Re: Bellmar Development Application (Collier County) and Public Notice, #396364-001

On behalf of our respective organizations and our members, the Center for Biological Diversity, Conservancy of Southwest Florida, and Sierra Club are providing comment on the Bellmar project proposal that is being sought under the Florida Department of Environmental Protection (FDEP) state assumed 404 program (application #396364-001). This letter supplements our prior

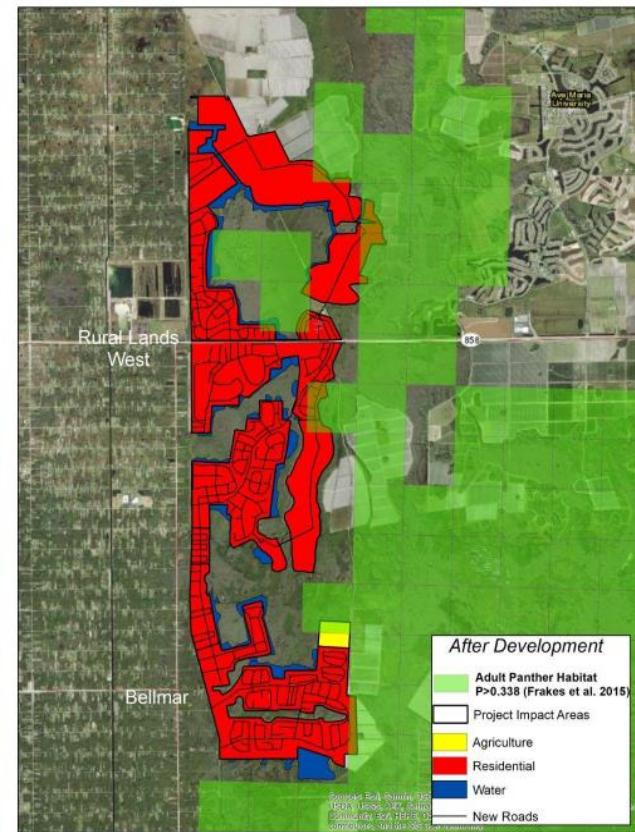
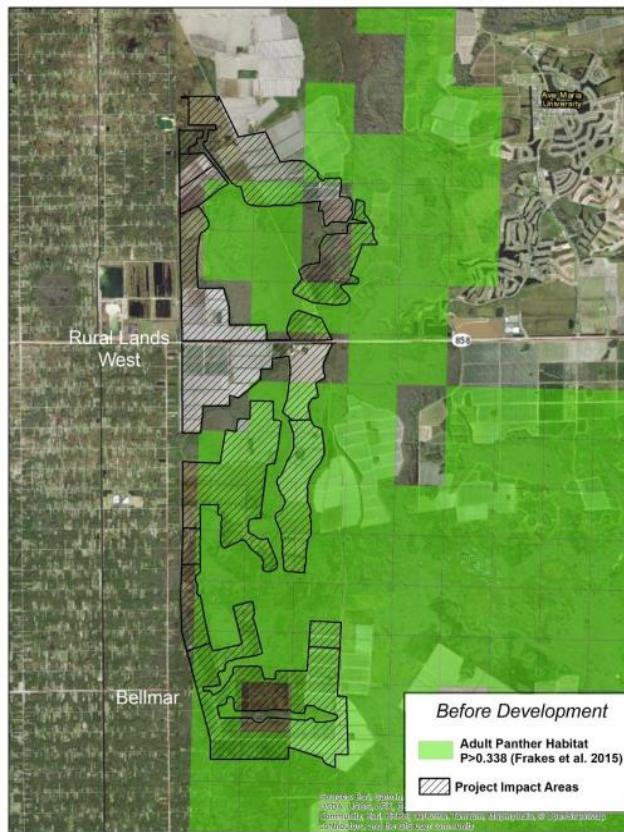
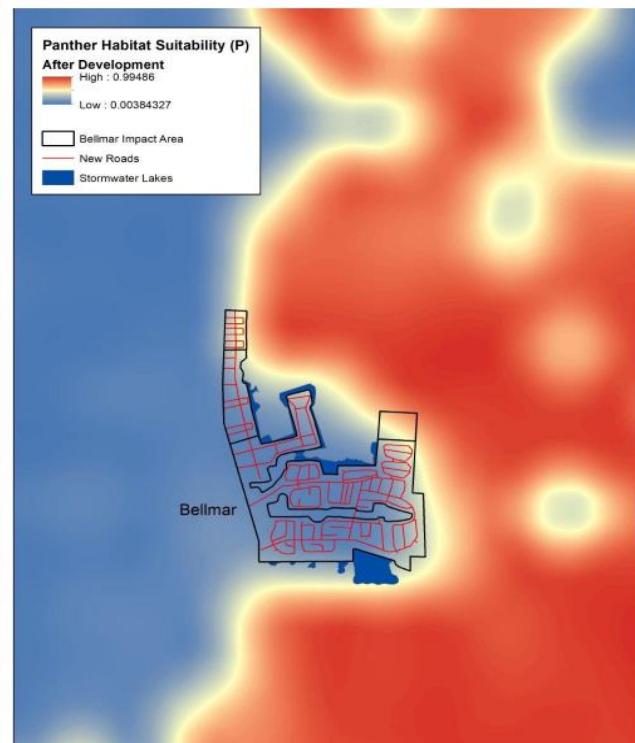
Using this published model with updates, Dr. Frakes compared the existing conditions to post-project scenario for Bellmar alone as well as Bellmar and RLW together. There is one set of maps to show the raw results and one set to show in an interpolated model that “smooths” the cells.

Frakes et al., 2015 acknowledges that “protection of the remaining breeding habitat in south Florida is essential to the survival and recovery of the subspecies and should receive the highest priority by regulatory agencies.”¹¹⁸ Yet, adult breeding habitat maps show that Bellmar alone will cause the loss of 10 km² (2,471 acres) of breeding habitat.

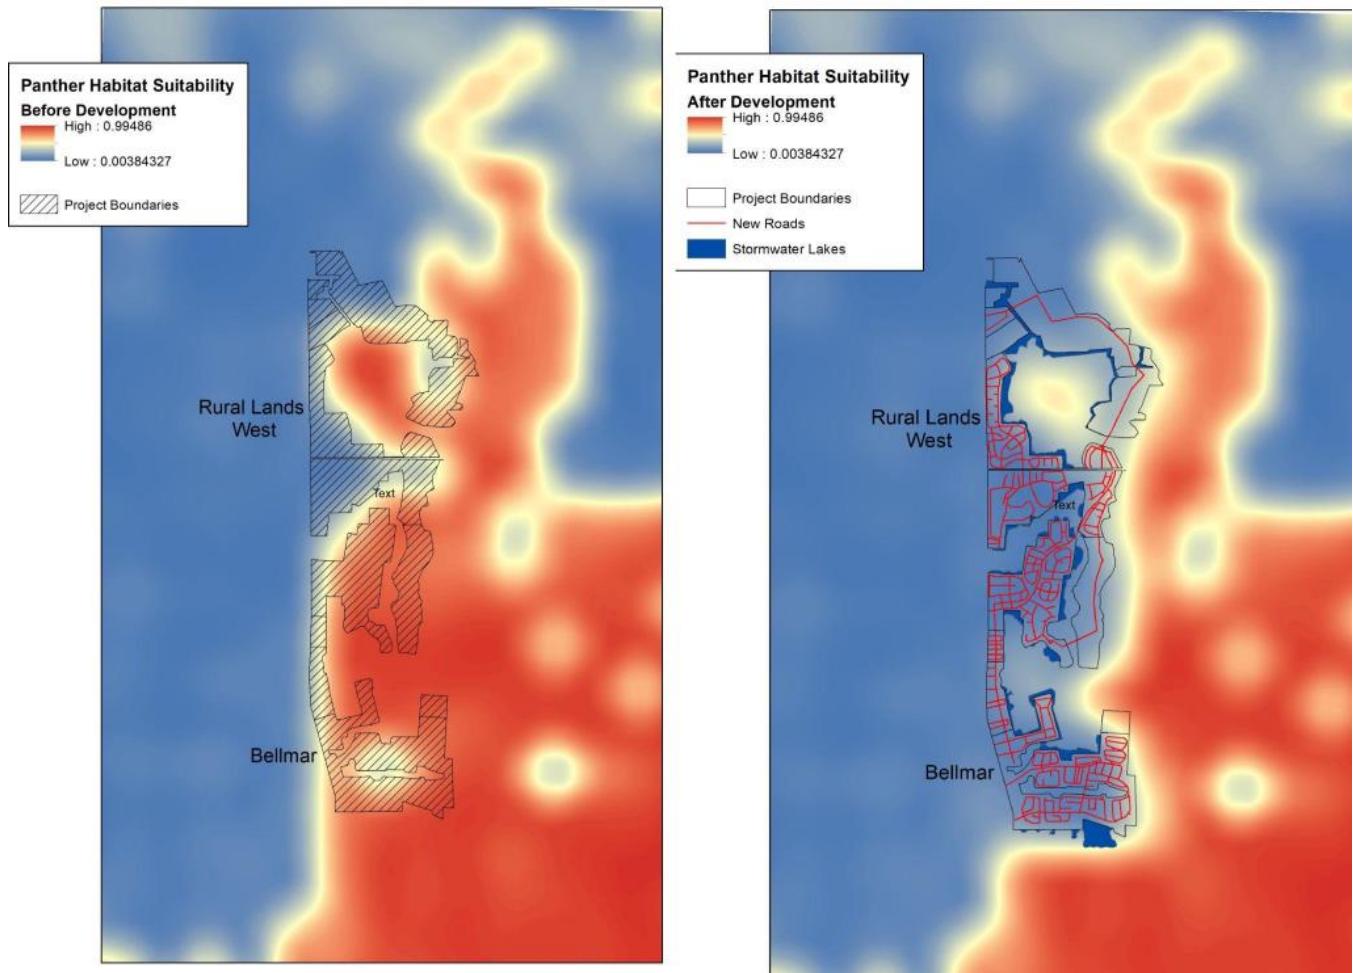
When Bellmar is combined with RLW, it would cause a combined loss of 23 km² (5,683 acres). The interpolated maps show a significant narrowing of the Camp Keais Strand dispersal corridor, especially when Bellmar and RLW are considered together.
